## Indoor Station Firmware Release Note

Device Model	DS-KH8350-WTE1, DS-KH8350-TE1, DS-KH6320-WTE1, DS-KH6320-TE1, DS-KH6320Y-WTE2, DS-KH6320EY-WTE2, DS-KH8520-WTE1, DS-KH6320-WTDE1, DS-KH6320-TDE1
Firmware Version	V2.2.96_build241111

# Indoor Station Firmware V2.2.92\_build241008

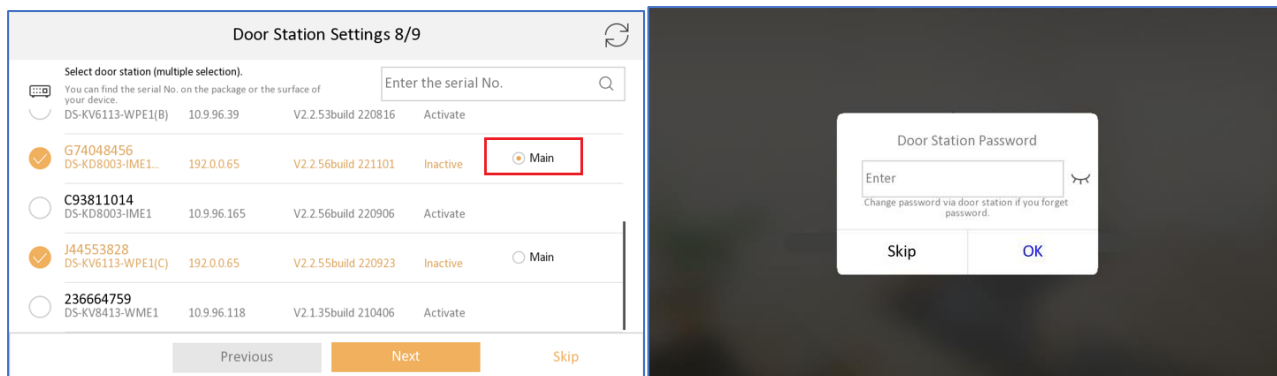
A. Quick setting for registration password

After checked, the registration password of indoor station will be consistent with its activation password, no need to input manually.

## D. Pairing with main door station, sub door station and indoor extension

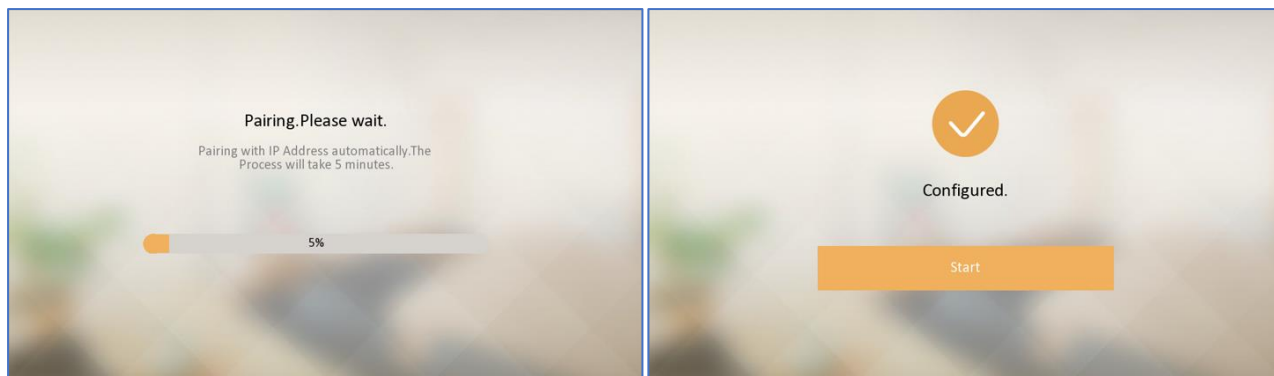
**Note:** The pairing time duration depends on the device quantity you selected in previous steps, it will take about up to 5 mins, please wait patiently until the process finish and show "Configured" as below.

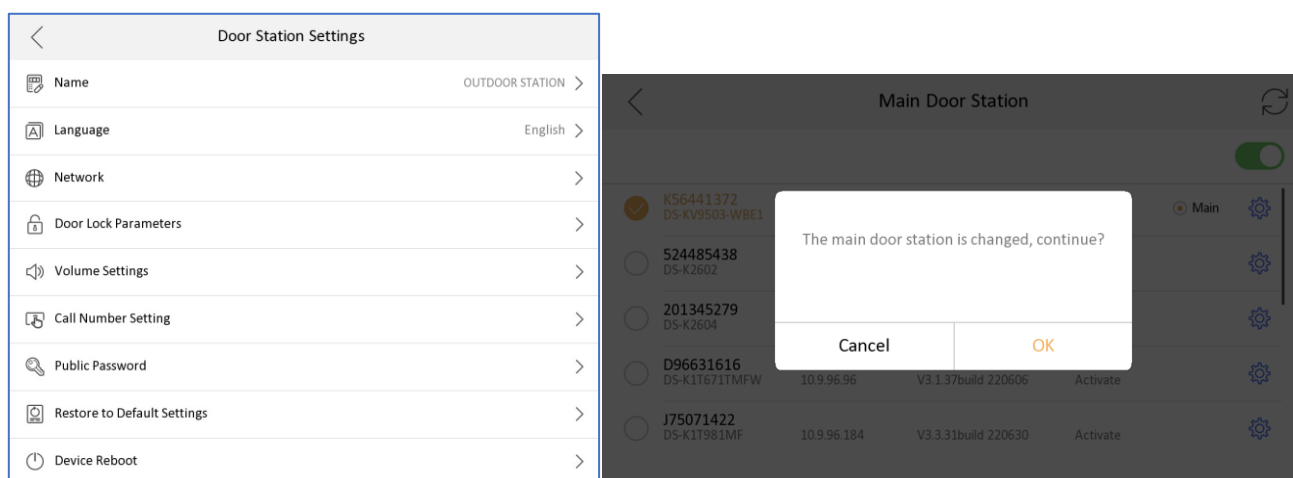
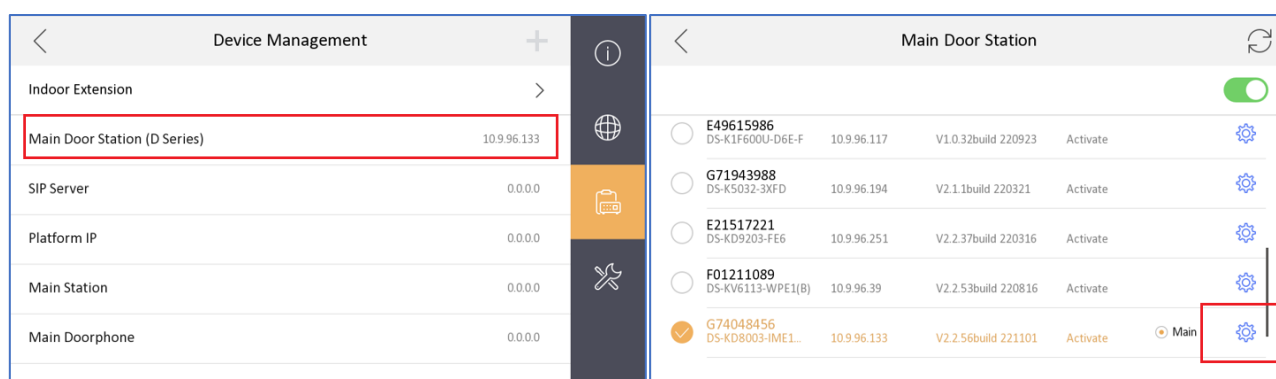
11. Set the important parameters of door station from indoor station Menu-Advanced settings-Configuration-Device Management-Main Door Station (*not from the wizard*).

- A. You can change parameters of all door station (no matter it's linked or not) in the list by click the setting icon, see pic 2.
- B. You can also change linked main door station from this list by click device from the list, if you want to change linked sub door station, please go to Advanced settings-Configuration-System maintenance-Wizard, and link device again.
- C. After change the linked main door station, device will prompt "The main door station is changed, continue?", see pic4 as below

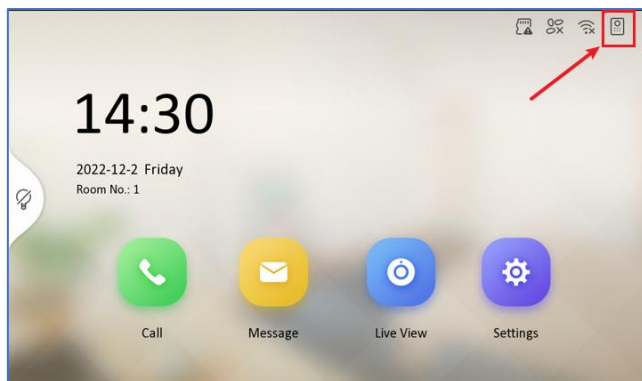
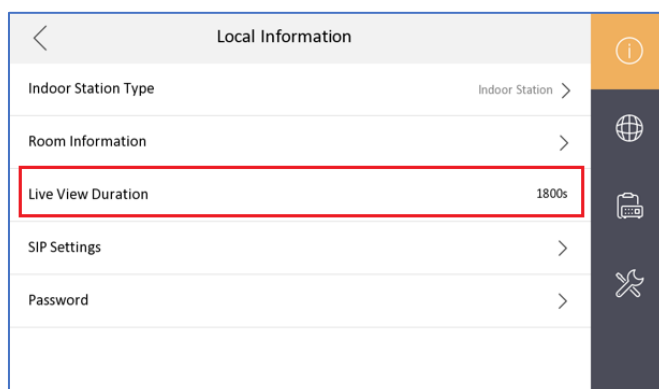
- Optimized the icon of door station registration status in the main UI up right corner.

*Note:* If the door station call indoor station failed, you can click this icon  to register to door station manually, if register failed, it will indicate the reason for the failure.

Before	Now
Indoor station registers to door station success		
Indoor station registers to door station failed		
Indoor station registers to door station and KM9503 success

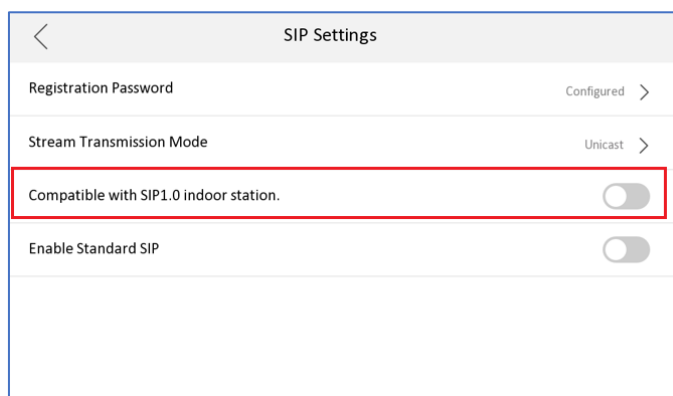
- Support switching between protocol 1.0 and 2.0, by default it's protocol 2.0  
After enable, the indoor station is compatible with protocol 1.0 indoor extension and not compatible with protocol 2.0 indoor extension.

**Note:** After enable, all indoor extension of this indoor station must be protocol 1.0 firmware, don't mix protocol 1.0 and 2.0 indoor extension under same indoor station, or it will result to calling failed.

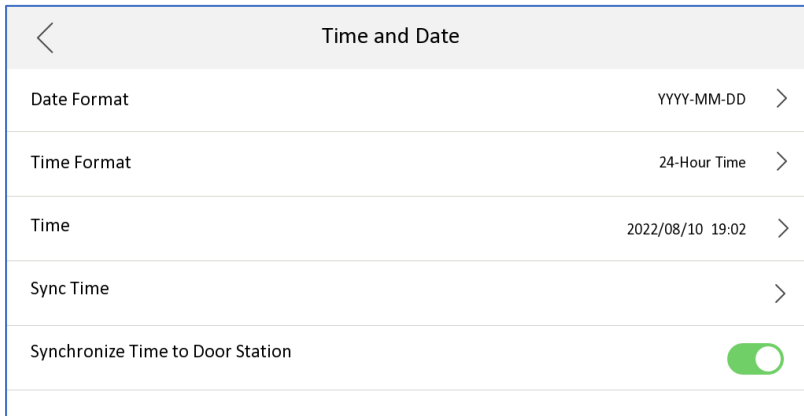
1. Supports static IP address configuration of Wi-Fi (DHCP, IP address, subnet mask, gateway, DNS1, DNS2).

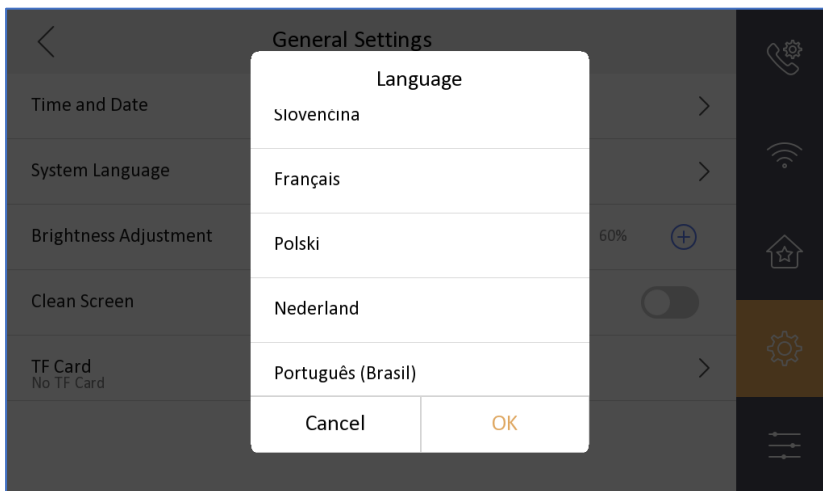
2. Supports configuring time and time zone for the door station.

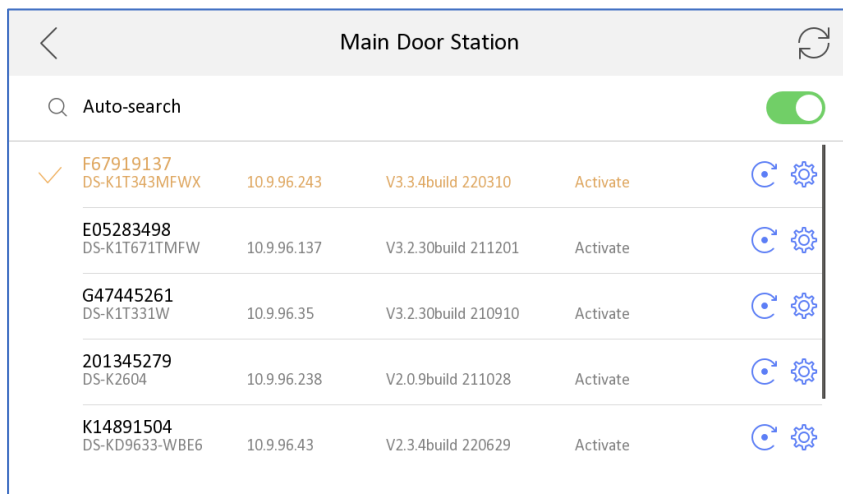
1. Optimizes the maintenance interface with a pop-up window when clicking **Restore** or **Restore All**.

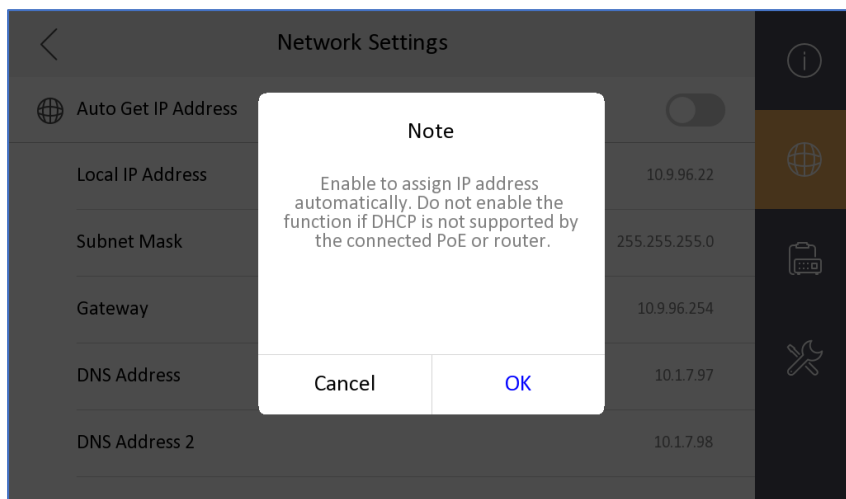
2. Adds the effect of selected door station when relating devices in wizard.

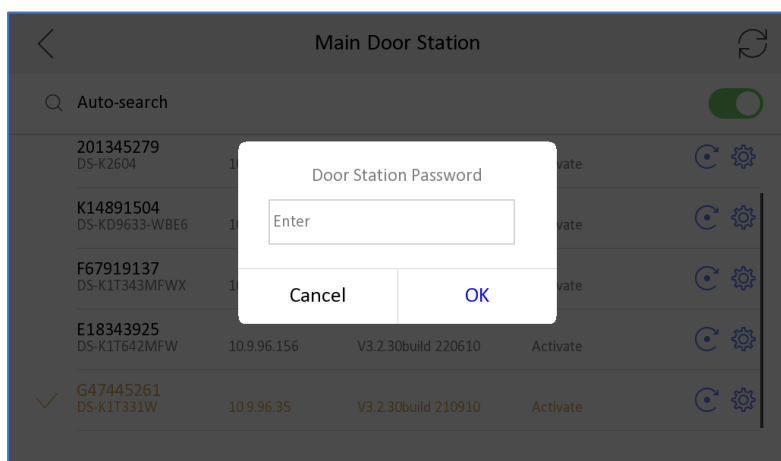
3. Adds a prompt when assigning network IP address automatically.

4. In configure wizard to related door station, when the door station password is different from the indoor station, prompt information will pop.

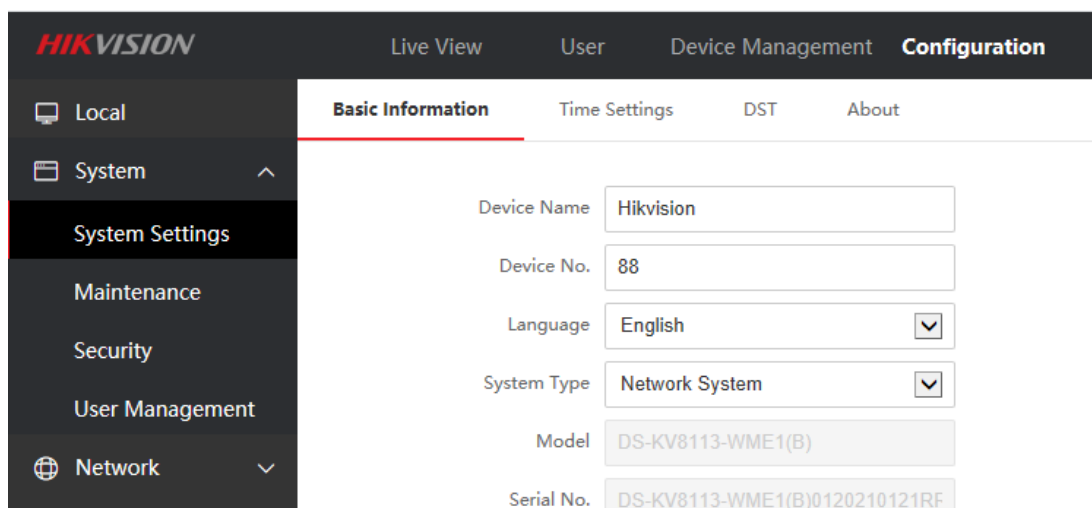
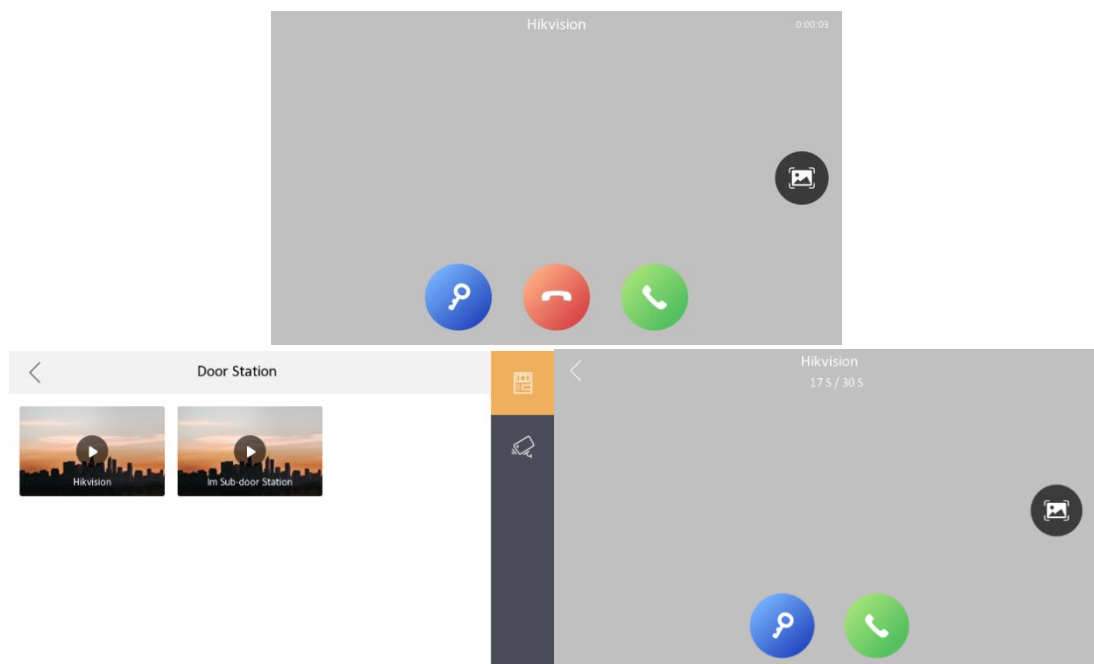
1. Change the position of unlock password and duress code, to enter the password page requires an admin (activation) password.

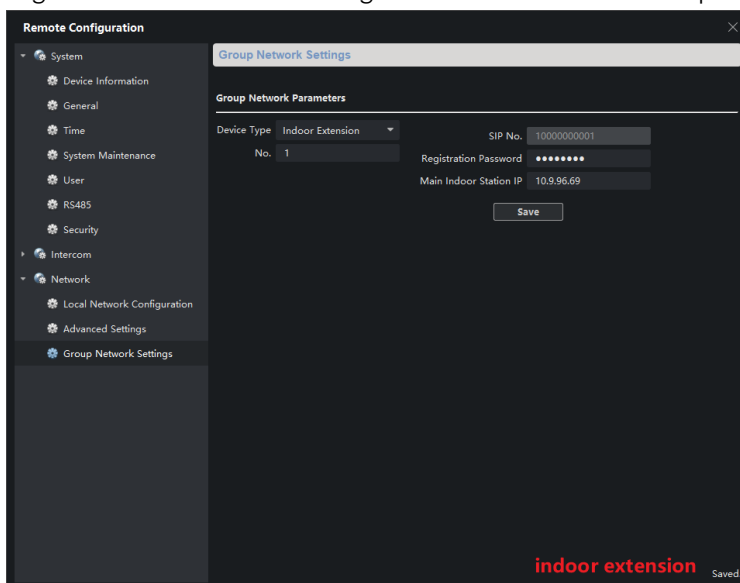
- The local interface community number, building number, and unit number of the indoor station will be stored in the advance column instead of being displayed directly

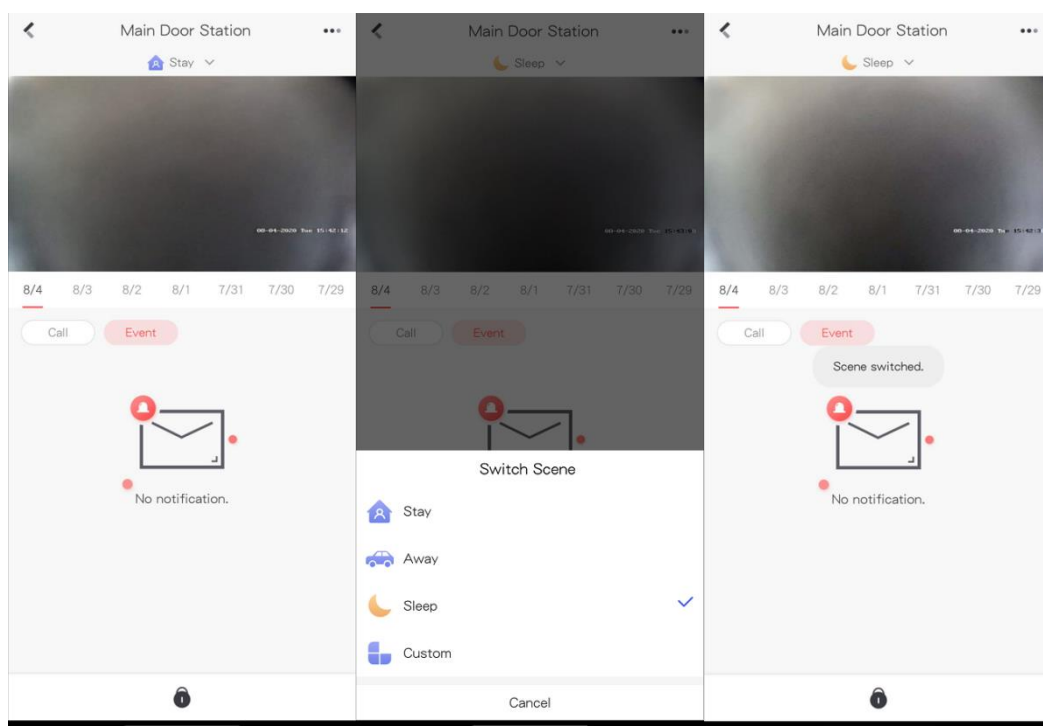
2. Support three date formats, two clock format configuration (Time format only allows local modification)

1) Support three formats in Settings->General Settings->Time and Date interface, set year-month-day, day-month-year, month-day - year

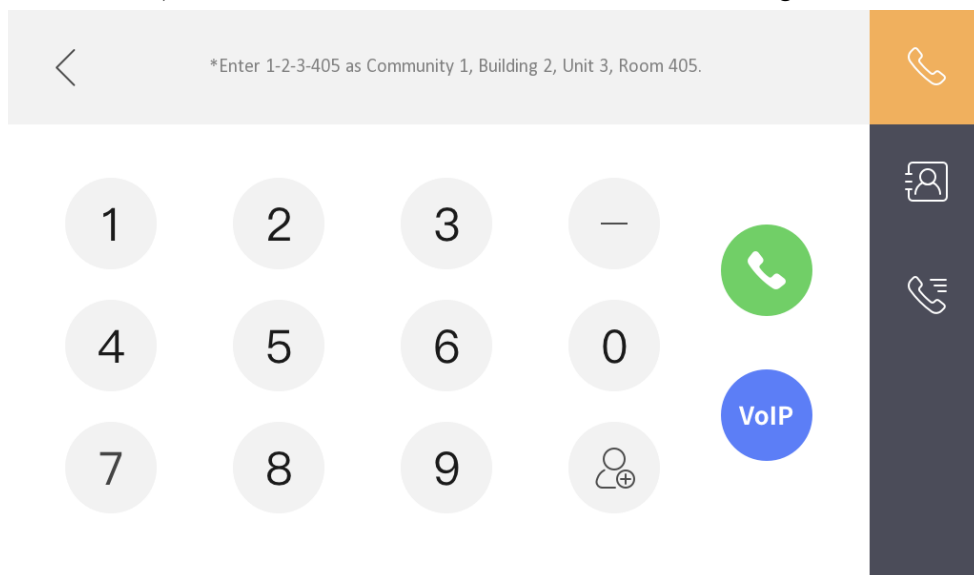
d) Added a VoIP call button in the call interface to distinguish standard SIP calls
